**RE: Response Letter
Sullivan Subdivision Application
112 High Street
Tax Map 19, Lot 68
JBE Project No. 13070.1**

Re: Subdivision Plan Review – Sullivan
Tax Map 19, Lot No. 68
112 High Street, Stratham, NH
Our Reference No. 1768

Plan Name: **EXISTING CONDITIONS PLAN**
Project: **SULLIVAN SUBDIVISION**
112 HIGH STREET, STRATHAM, NH 03885
Owner of Record: **ROBIN SULLIVAN**
8 WHITTAKER DRIVE, STRATHAM, NH 03885

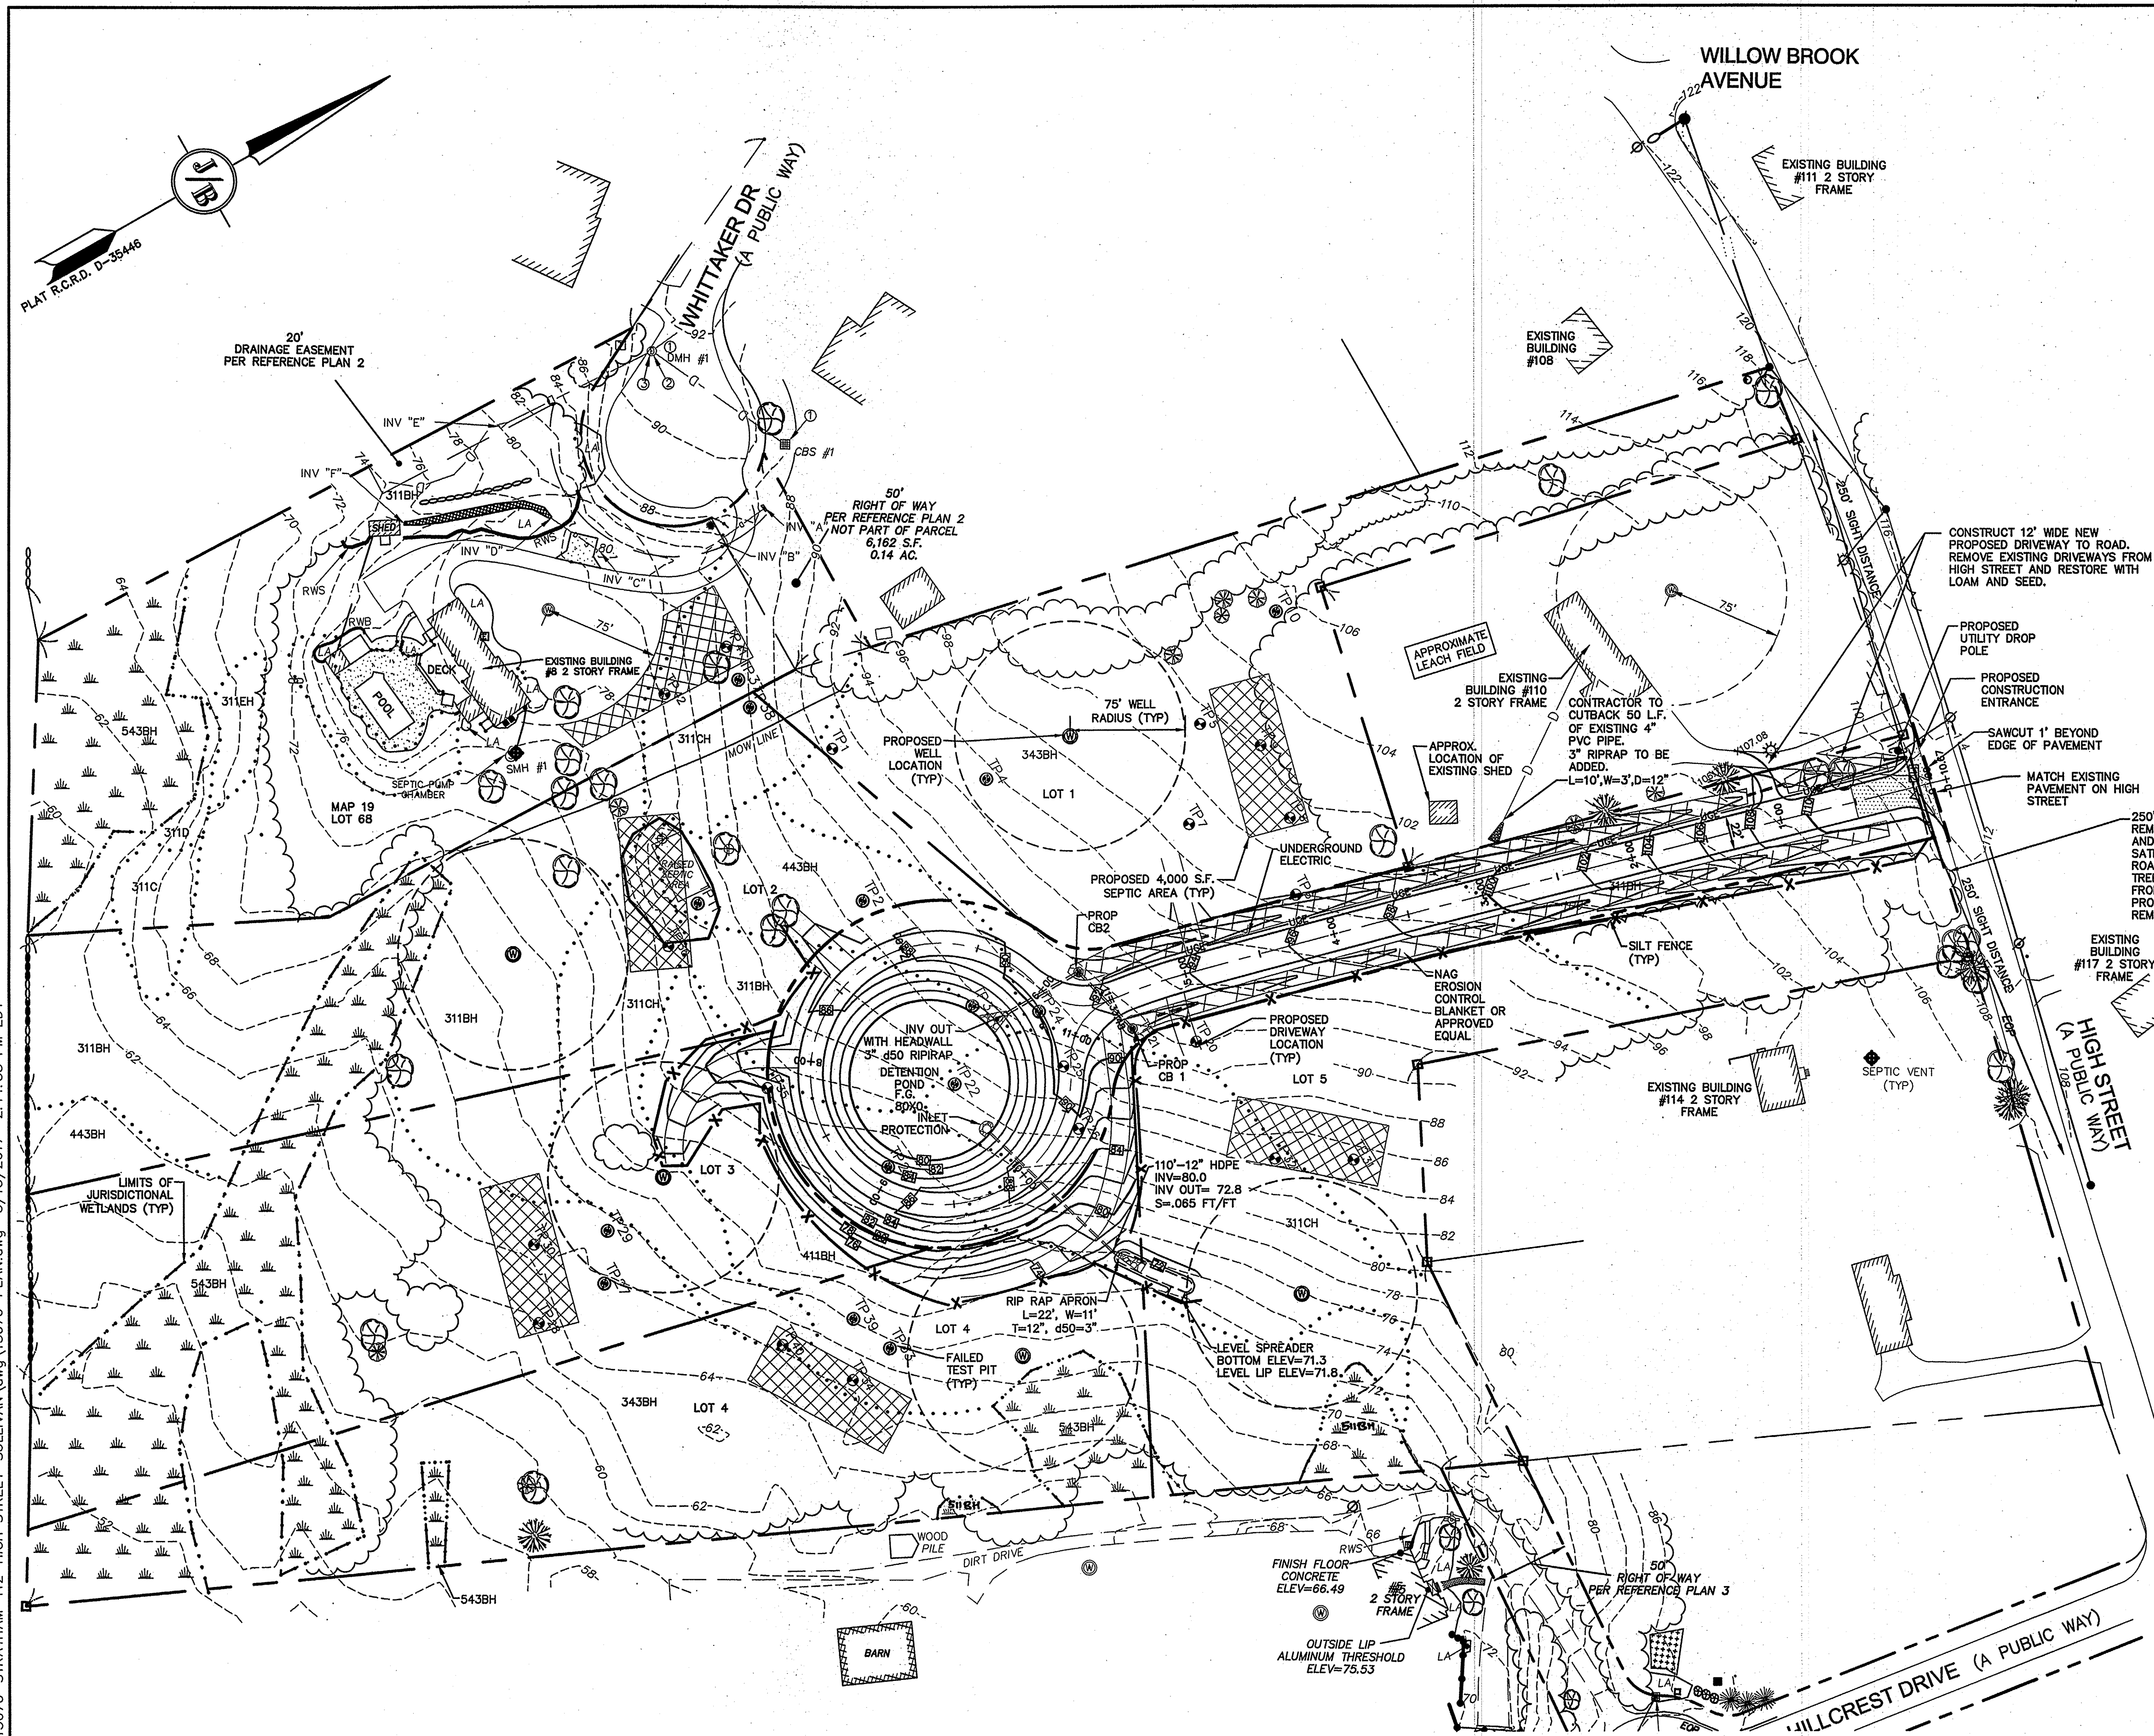
2. NHDES Subdivision Approval will be required for this subdivision proposal.
3. A "HISS" mapping legend should be provided on plan sheet C1 and C2 for proper interpretation of the "HISS" mapping data shown.

4. The available safe sight distances should be identified and shown for the proposed roadway's intersection with High Street.
5. We have no submitted data or logs for Soil Test Pits identified as #1 through #20 shown on plan sheets C1 and C2.

Plan Name:	GRADING AND DRAINAGE PLAN
Project:	SULLIVAN SUBDIVISION 112 HIGH STREET, STRATHAM, NH 03885
Owner of Record:	ROBIN SULLIVAN 8 WHITTAKER DRIVE, STRATHAM, NH 03885

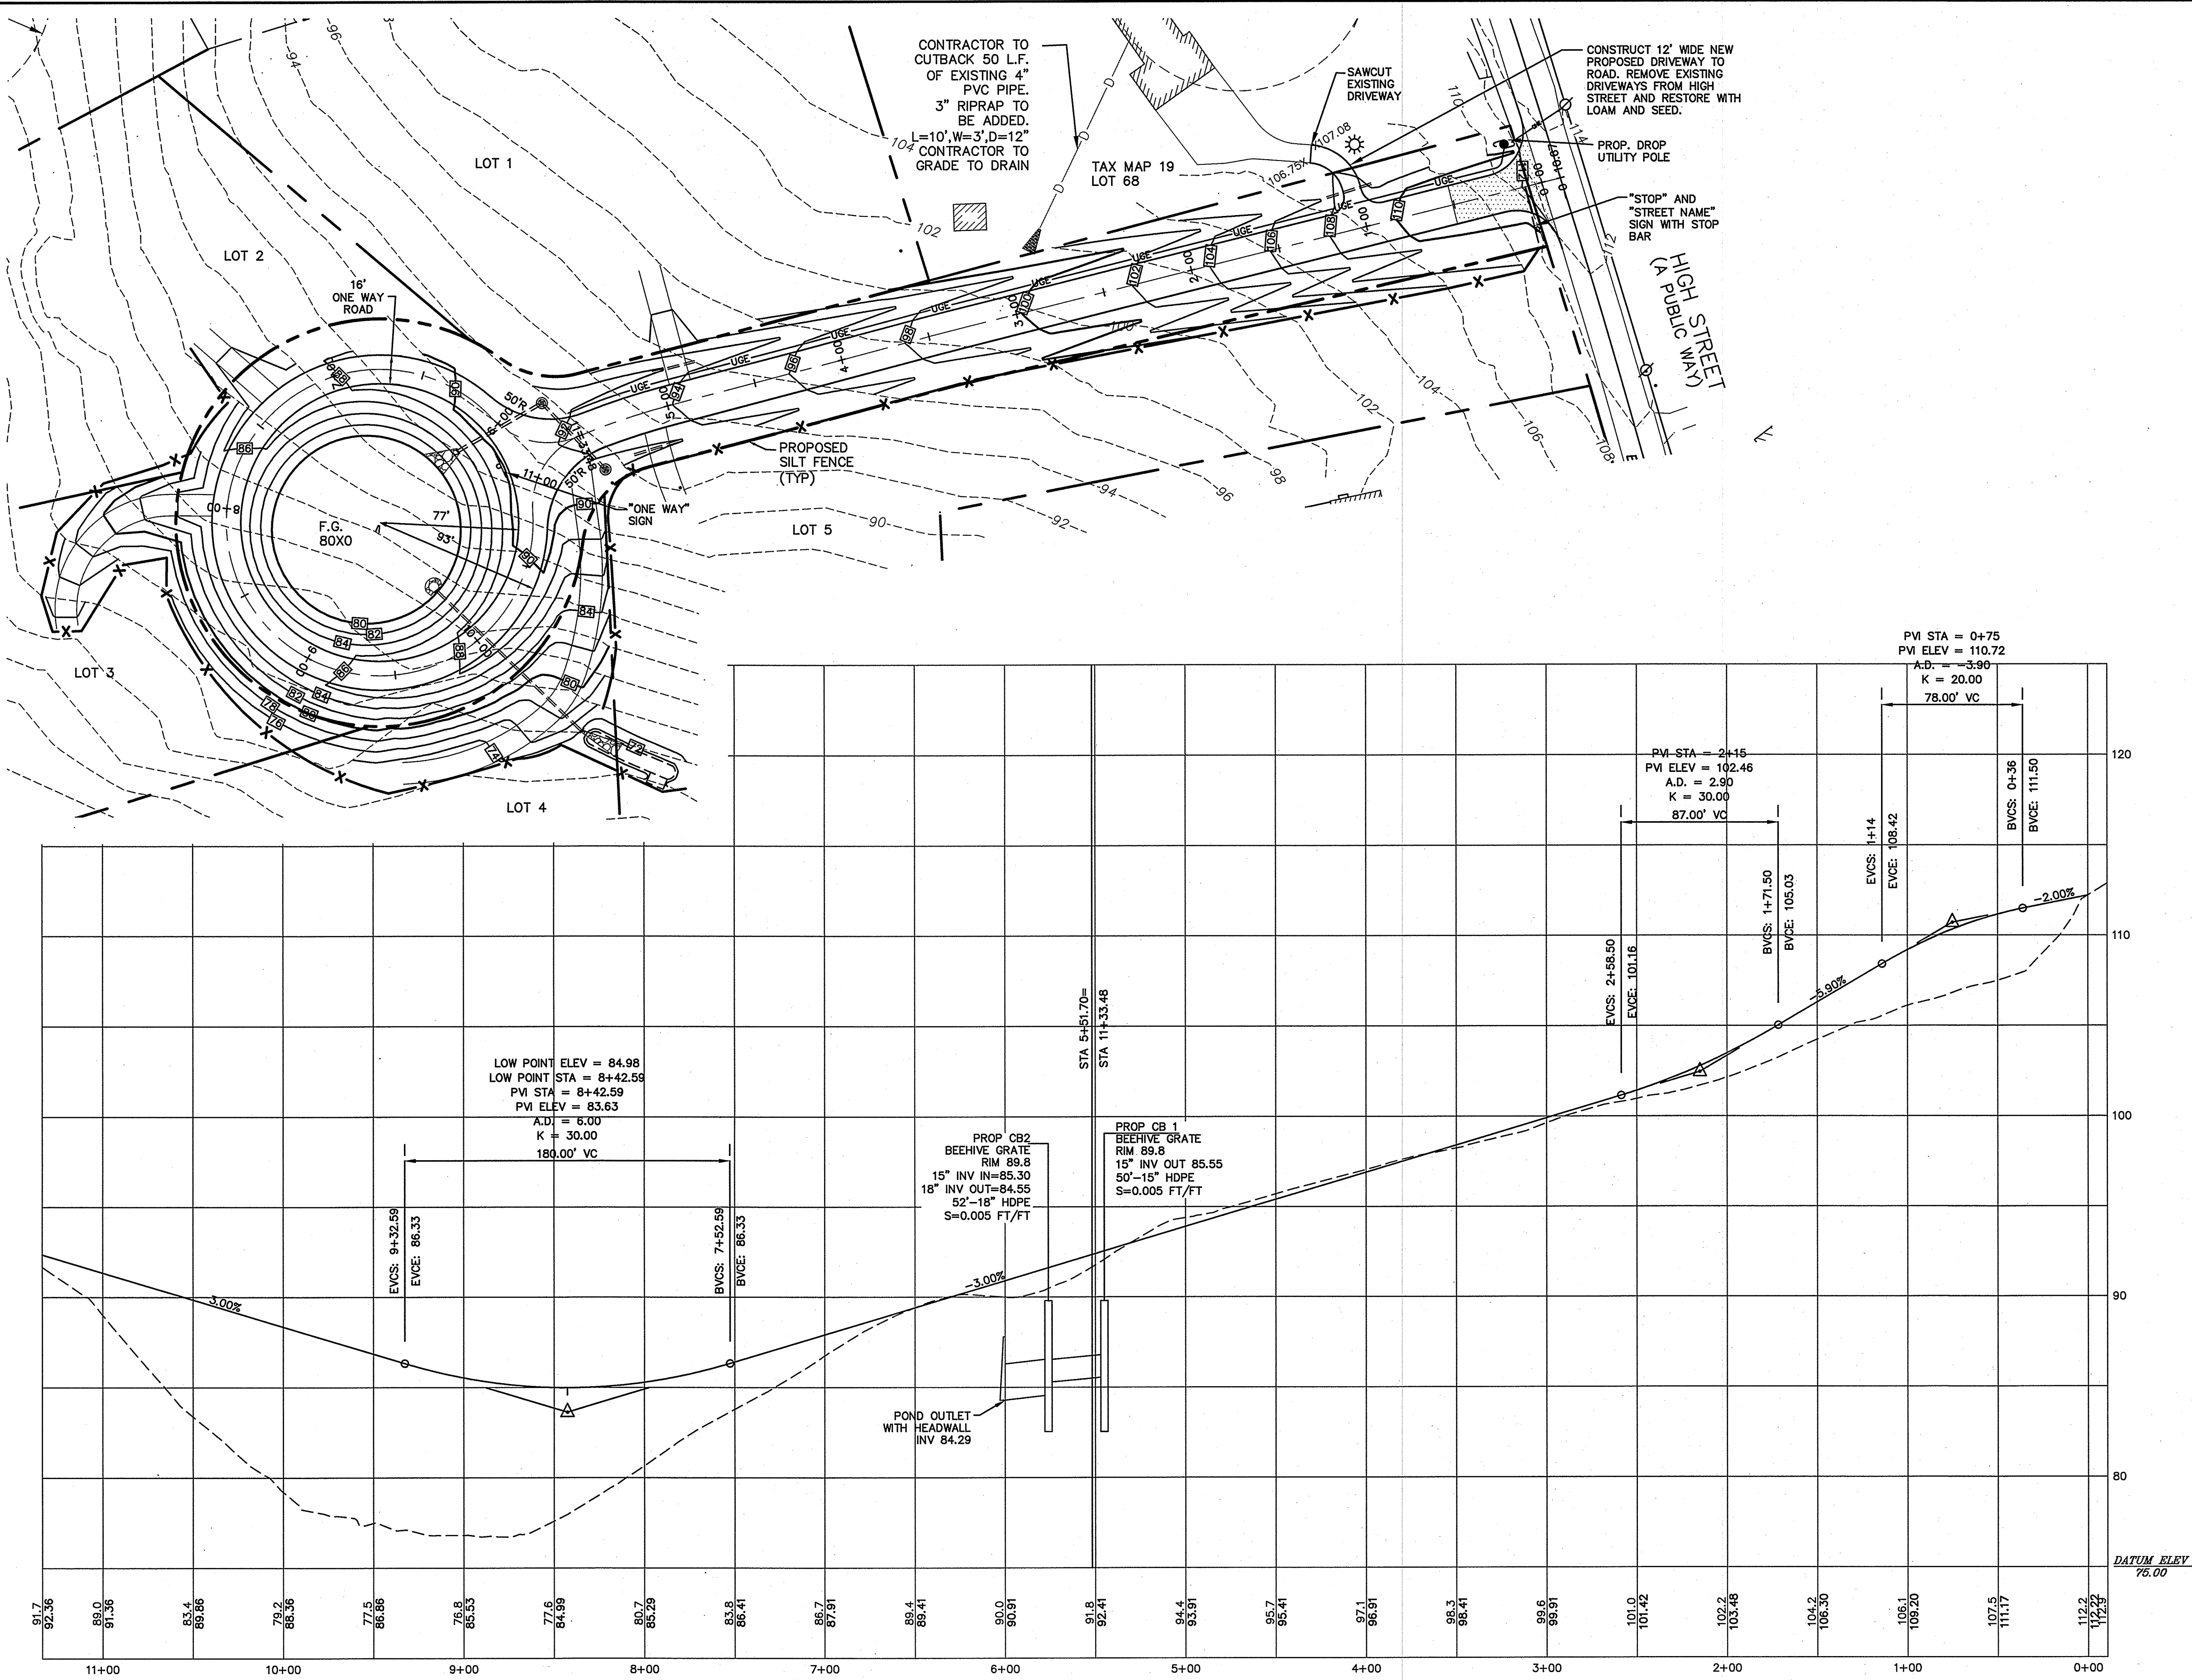
7. The required sight distance is shown on Sheet C2.

TYPICAL ROADWAY SECTION

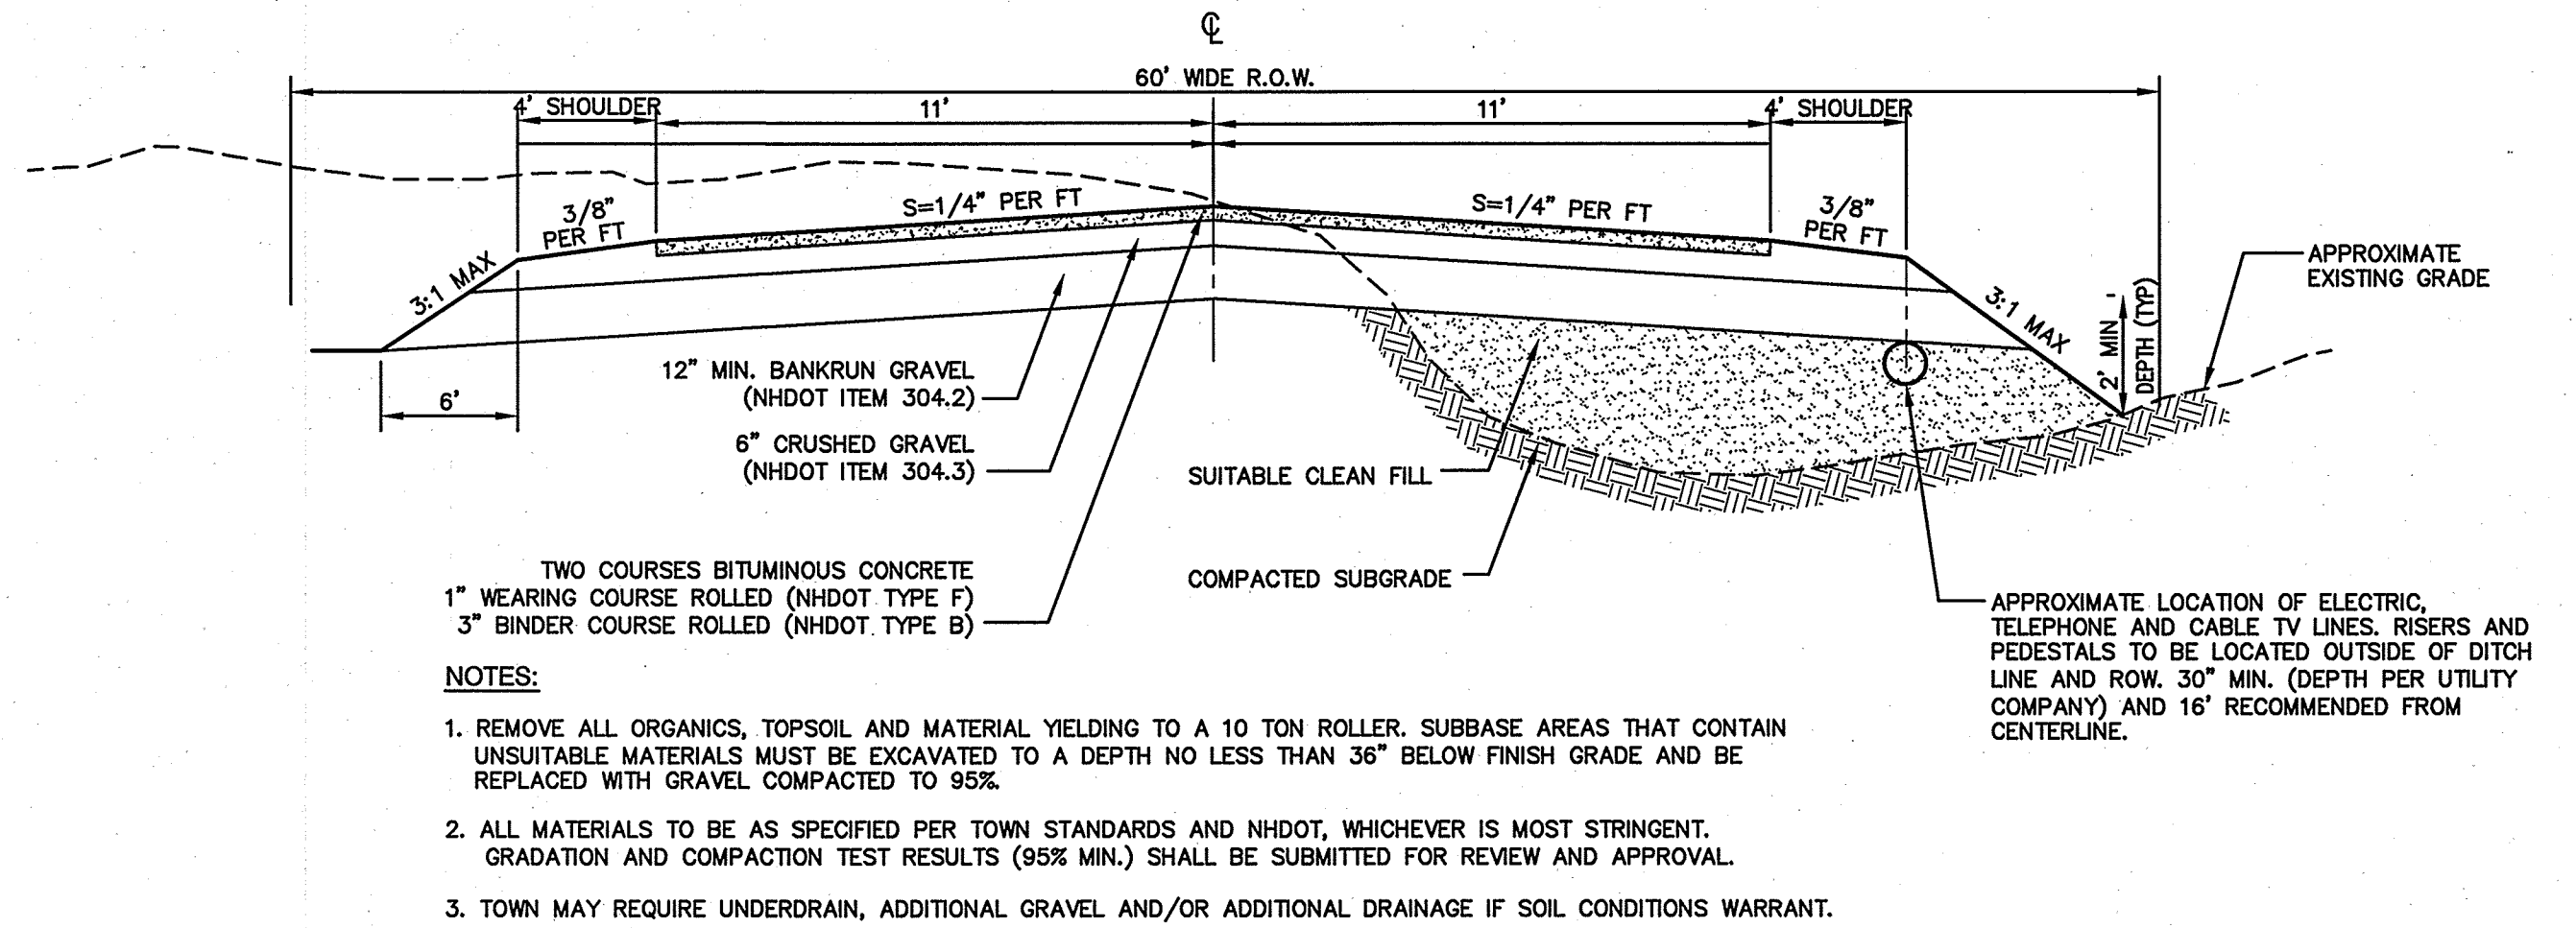
1. A NHDOT specification should be shown and included for the "suitable clean fill" called for in the "TYPICAL ROADWAY SECTION" shown on plan sheet D1.
